# Access Compliance Report

## Public Rights-of-Way

### (Curb Ramps)

Intersection ID: 47571	Main Street: SEDGEBURN_DR	Cross Street: HERMSLEY_RD	Location: NE
ADA ID: F6D44D7336B5	Ramp Type: PerpDiag	Initial Pass/Fail: Fail	Overall Compliance: No
		Severity Score: 22.5

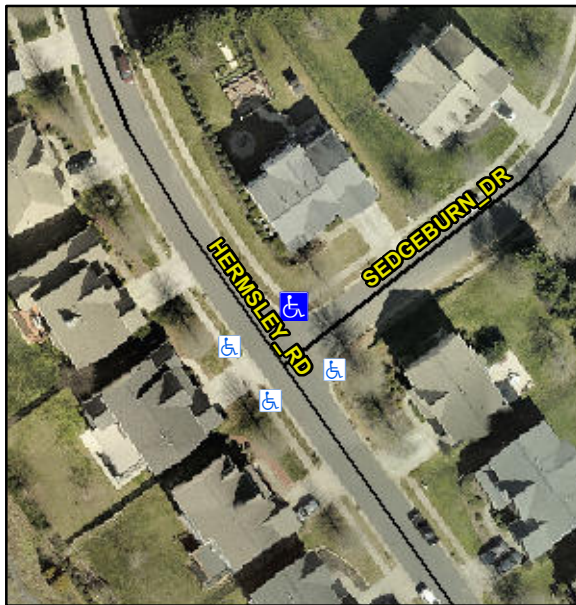
**Not Found, R304.5.1, R304.2.2, R304.5.3**

Compliance	Description	Data	Compliance	Description	Data
N/A	Ramp Length (in)	49.0	No	Ramp Slope (%)	8.8
No	Ramp Width (in)	43.0	No	Ramp XSlope (%)	2.8
N/A	Flare Type LT	N/A	N/A	Flare Type RT	N/A
N/A	Flare Slope LT (%)	N/A	N/A	Flare Slope RT (%)	N/A
N/A	Flare Traversable LT?	N/A	N/A	Flare Traversable RT?	N/A
N/A	Landing Length (in)	N/A	N/A	DWS Provided?	N/A
N/A	Landing Width (in)	N/A	N/A	DWS Contrast?	N/A
N/A	Landing Slope (%)	N/A	N/A	DWS Length (in)	N/A
N/A	Landing X Slope (%)	N/A	N/A	DWS Full Width?	N/A
N/A	Landing Curb? (Y/N)	N/A	N/A	DWS Offset (in)	N/A
N/A	Shared Landing?	N/A			
N/A	Gutter Ponding?	N/A	N/A	Gutter Slope (%)	N/A
N/A	Gutter Lip Ht (in)	N/A	N/A	Gutter X Slope (%)	N/A
N/A	Painted X Walk1?	No	N/A	Painted X Walk2?	No
	X Walk 1 Direction	To SW		X Walk 2 Direction	To SE
N/A	X Walk 1 Width (in)	N/A	N/A	X Walk 2 Width (in)	N/A
	X Walk 1 Slope (%)	1.3		X Walk 2 Slope (%)	6.9
	X Walk 1 X Slope (%)	5.9		X Walk 2 X Slope (%)	2.3

**Remove & Replace Curb Ramp With Two New Directional Ramps or Equivalent.**
